M	VP Vari	ance Req	uest	Form	Varia	ance Request		1.4.4
	No.: Date Approval Requested by Contractor:				I-11 7/27/2018				
Mou 🌄					•	spector to LEI:	1/2	7/2010	
Y Valley PIPELINE uc			Da	le Sub		•	ived by FERC:		
			FERC	Approv					
	FERC Approval Reference No.: Variance								
Requested By:	N	lark Torbic		;	Spread:		Туре:		WS
Beguest Brenered By *:						Variar	nce Sequence		011
Request Prepared By *: * The EERC compliance mo		Megan Neylon Number: 011 nitor should be alerted and given a copy of the draft variance for review prior to submittal.					011		
The r Erro compliance me			Jse either Sta					ubrinitiai.	
Station:	15260+00	To:	15260+00		ilepost:		То:	2	89.55
otation.	13200+00	10.	13200+00		inepost.	203.00	10.	20	09.00
Alignment	Sheet Number:	314 Tract No.:				VA-PI-025			
Current Land Use/Va	Current Land Use/ Vegetative Cover:		is Forest; Everg. Forest	reen		r Agency sdiction:			
Nearby Features (Water b				ed	Jun	Sulction.

Mountain Valley Pipeline Project Variance I-11 July 30, 2018

Variance I-11

> Alignment Sheets Attachment 1

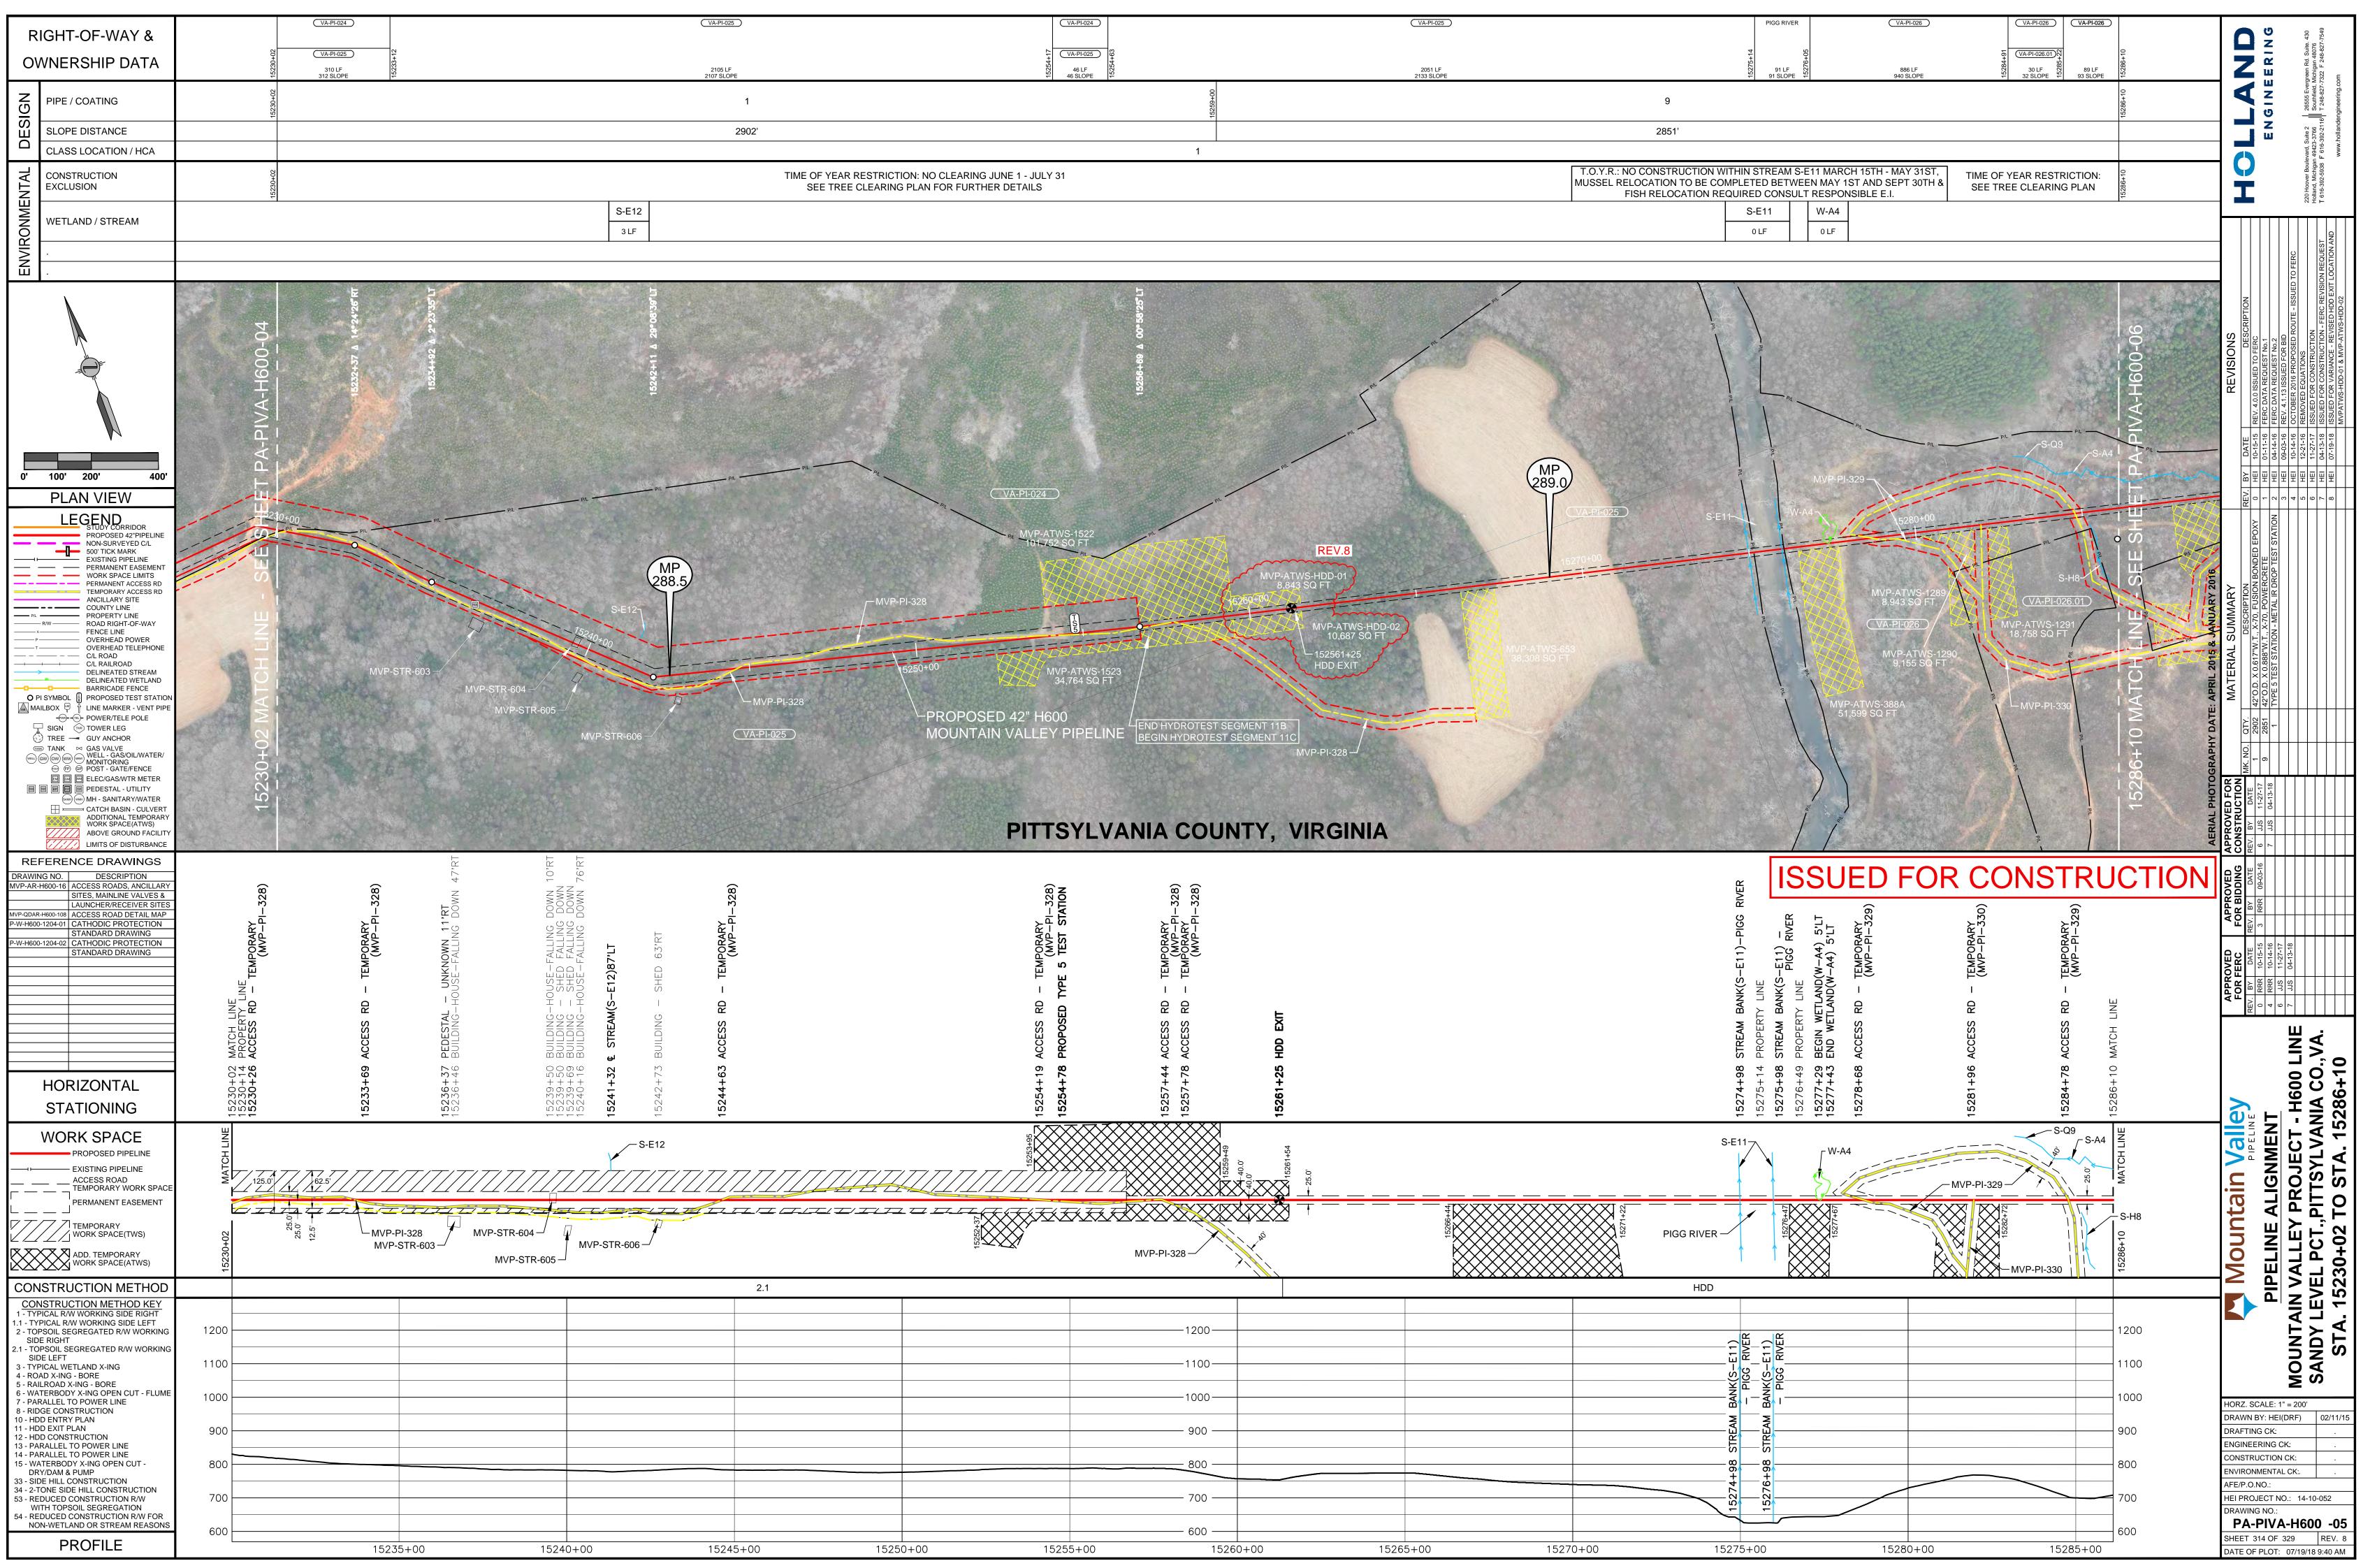
Area, Residence (distance					In or	r w/in 50'	of a wetland:	🗌 Yes	☑ No
	-	esidence (Dis		-	In or w/i	in 50' of a	a waterbody:	🗌 Yes	✓ No
T/E Species Habitat	ultural Resource Site	🗆 Wa	ater Well				-		N/A
Other (Specify):	ΔΔΡ	Y0437			Wet	tland or V	Vaterbody ID:	ody ID: N/A	
Additional Stream									
footage impacted:	0.00				Additi	onal Wet	land impacts:		0.00
Net acreage affected:	+ 0.45		_	- 1					
Tree Clearing Required:	No		Acreage o	of tree aring:	0	.00			
				aring.	0.	.00			
Variance Level:	Level 1	Level 2	✓ Level 3						
Variance From:	Permit 🗌 Plan	Procedur	es 🗌 EPPM		Specificatio	on 🗌 Dr	awing 🗌 Miti	gation Meas	sure
L	Line List				Other: Des	cribe:			
Detailed Description of Va	ariance:	Attachmer	nts? 🛛 Y	es 🗌	No	Photo	os?	Yes 🗹	No
This variance adds addition	al workspaces M	VP-ATWS-	HDD-01 & MV						
of the Pigg River HDD. Cultural Resource 44PY0437 was found near this variance. The SHPO Clearance letters can be found in Attachment 4. No streams or wetlands were delineated during surveys. This variance has a net increase of 0.45 acres of LOD

from the original permit. The					variance	e nas a ne	t increase of U.	45 acres	of LOD
		anng requi		ance.					
List Attachments: Attachment 1-Alignment Sheet; Attachment 2- Rare, Threatened, and Endangered Species Report; Attachment 3- Waterbodies and Wetlands									
Report; Attachment 4- Cultural and Historic Resources (CUI//PRIV									
DO NOT RELEASE); Attachment 5- Landowner Exhibits (CUI//PRIV DO NOT RELEASE); Attachment 6- Pipeline Variance Regulast Man									
DO NOT RELEASE) ; Attachment 6 - Pipeline Variance Request Map									
Variance Justification:									
Resources have been avoided to the extent practicable. Per approved Project plans, BMPs will be installed to minimize impacts to									
any Environmentally Sensitive Areas within/abutting the area.
